MODIFICATION INSTRUCTION SHEET No DX/14-1

EQUIPMENT AFFECTED: BridgeMaster E Flat Panel Monitors, 65823A and 65823B,

65817G and 65819A.

OBJECT AND METHOD: On a few occasions horizontal perturbations and mild

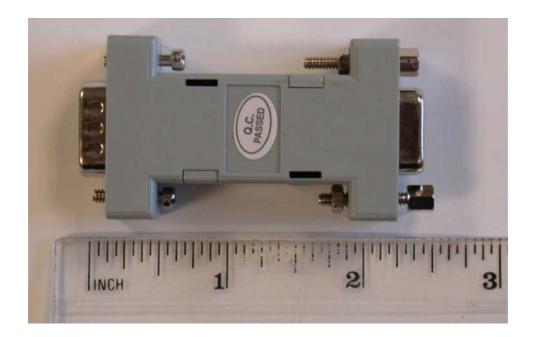
Item	Description	Code No	Qty	
1	Filter box (see picture)		MA00015156	01
(An alternati	ve cable 65800552 may be supplied:	instead)
